DHCD – Division of Building and Fire Regulation
2006 Code Change Cycle

COMPILATION DOCUMENT
(of all code changes received with staff evaluations)

PART III

**USBC – Virginia Construction Code
Code Change No. C-503**

Portion of IBC Table 503
Allowable Height and Building Areas

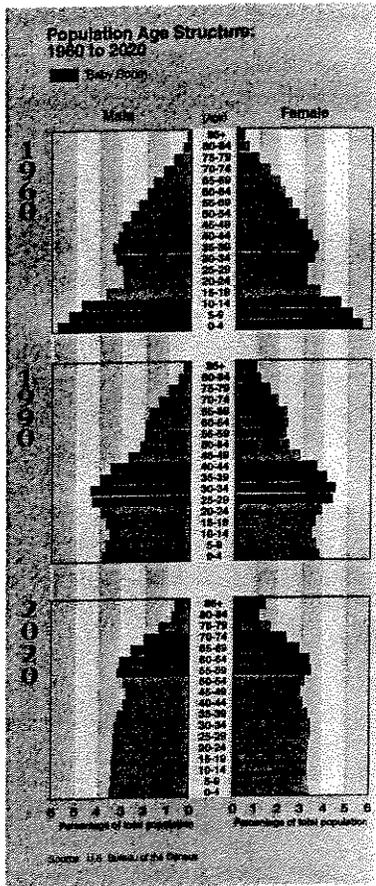
1. Revise Table 503 as follows:

Supporting Statement: This change will require that assisted living facilities (occupancy Group I-1) be built to the same type of construction standards presently required for hospitals and nursing homes (Group I-2). It will require a balanced approach to fire protection design resulting in the same level of fire safety in facilities housing this growing and fragile segment of the population as currently provided for patients in hospitals and residents of nursing homes. Adoption of the change will combine the benefits of passive and active fire protection for (1) fire containment, using non-combustible construction materials for facilities more than one story in height; (2) smoke detection and alarms; and (3) fire suppression, using sprinklers.
